**Report: ISSUES**

**Function: Test, Adjust, & Balance**

## **Forge HQ (Kansas City, MO)**

## Issue List

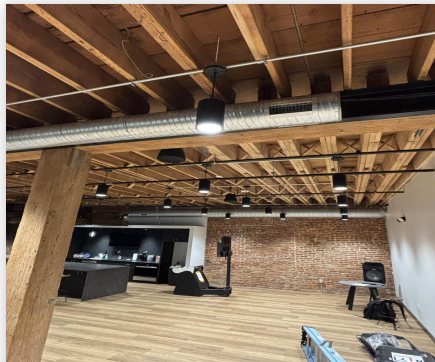
**Issue Name :** FCU-2: Broken Damper Handle  
**Description :** The damper handle is broken. The handle fell out when the insulation got pulled back. Need new damper installed.  
**Created By :** National TAB                      **Assigned To :** National TAB - Kalen Kemp  
**Status :** Open  
**Priority :** Urgent                                      **Asset Tag :** F2-2  
**Originated Date :** 09/24/2025 - Kalen Kemp - National TAB

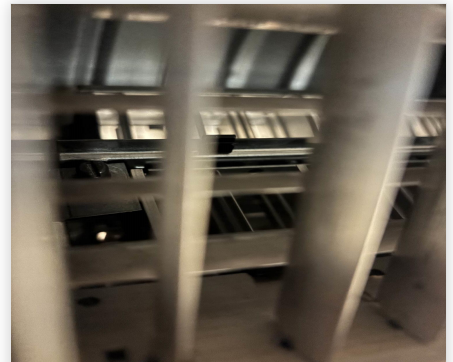
**Issue Name :** FCU2: Loose/Disconnected Face Damper  
**Description :** The face damper for the grille was loose. The damper came off the grille and fell into the duct when attempting to balance. Needs to be reconnected.  
**Created By :** National TAB                      **Assigned To :** National TAB - Kalen Kemp  
**Status :** Open  
**Priority :** Urgent                                      **Asset Tag :** F2-7  
**Originated Date :** 09/24/2025 - Kalen Kemp - National TAB
